No.	Description	Date
A	Planning amendment	24-01-21

PROJECT **64 Delancey Street**
London
NW1 7RY
CLIENT **Mr Pooja Shah**

Approved & Proposed
3rd Floor
DRAWING REF: **DEL64-PL2-GA03-rev A** REV **A**

Approved 3rd Floor Approved Plan : DEL64-PL2-GA03
2019/0935/P and 2019/1135/L

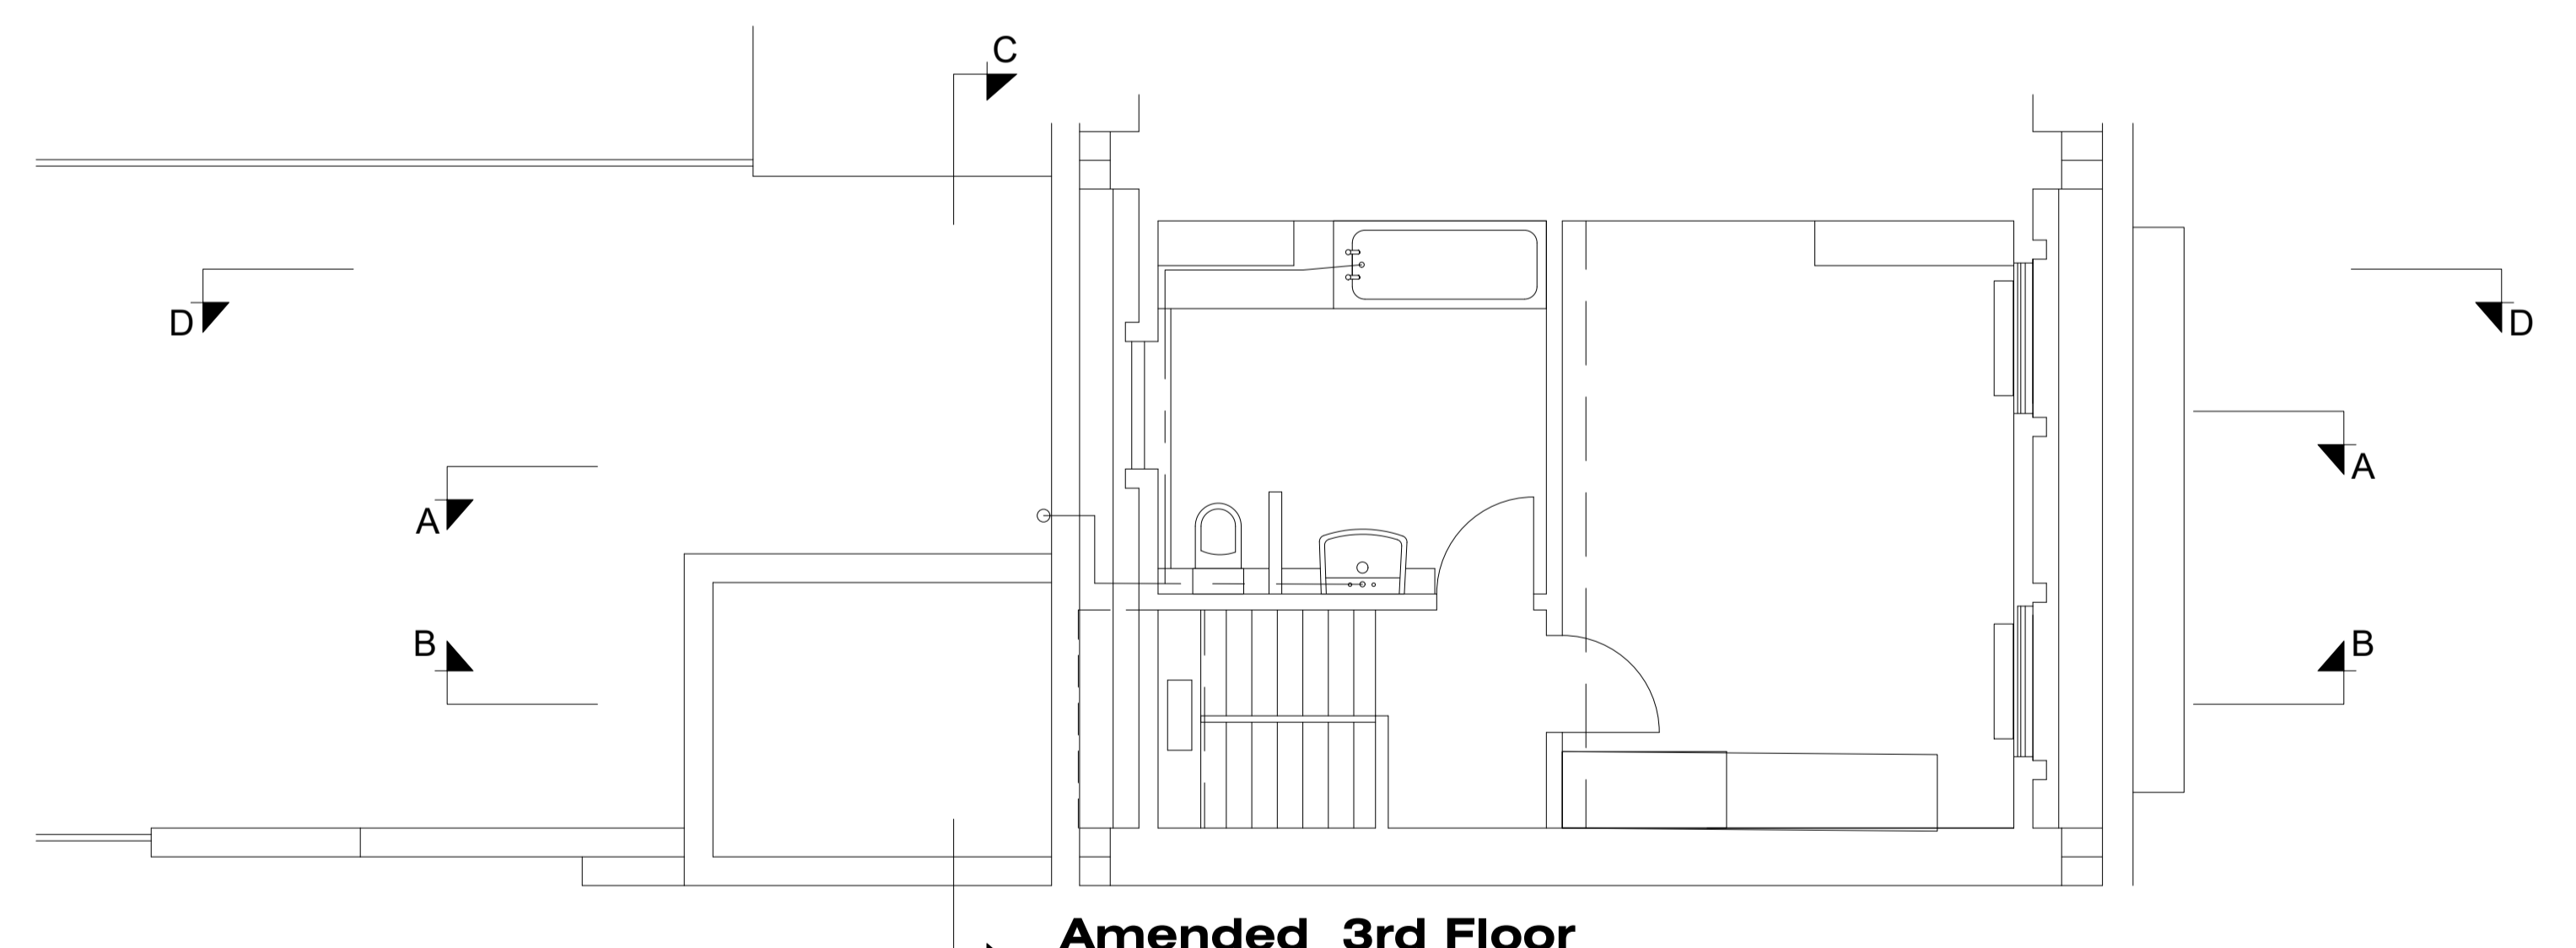
Amended 3rd Floor
